寄件者: Tang Lok San <[REDACTED]>
寄件日期: 2025年11月05日星期三 15:37
收件者: tpbpd/PLAND
副本: [REDACTED]
主旨: Re: S. 16 Planning Application No. A/YL-KTN/1155 - Departmental Comments
附件: AYL-KTN 1155 20251105.pdf

有關對古物古蹟辦事處 A/YL-KTN/1155 的查詢

Appendix 7	Location: DD 109 Lot 655 (Part)	Project:	Proposed Drainage Plan and Cross Section		Drawing No.
	OZP: S/YL-KTN/11	Proposed Temporary Holiday Camp with Ancillary Facilities and Associated Filling of Land For a Period of 3 Years			7-01
	District: Kam Tin North				For Identification Only
	Zoning: Agriculture				Date: 16 September 2025

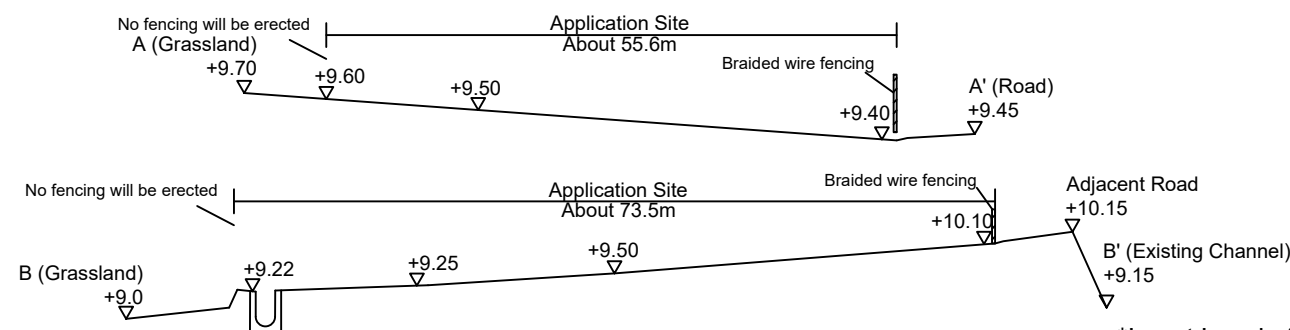
以免影響地下具考古研究價值的環境，本申請已將挖掘的位置及深度降至最少，務求將挖掘的影響減至最低。

由於需要在收集申請範圍及周遭附近的地面流水，我們已向渠務署提供渠務報告。現時計劃挖掘 3 條渠道，全部為 375mm 深度，長度分別為 11 米、40 米及 42.5 米。渠務報告請參考 Appendix 7，渠務報告當中紅色線為擬議渠道。

申請範圍內只會挖掘上述渠道，不會進行其他挖掘工程。
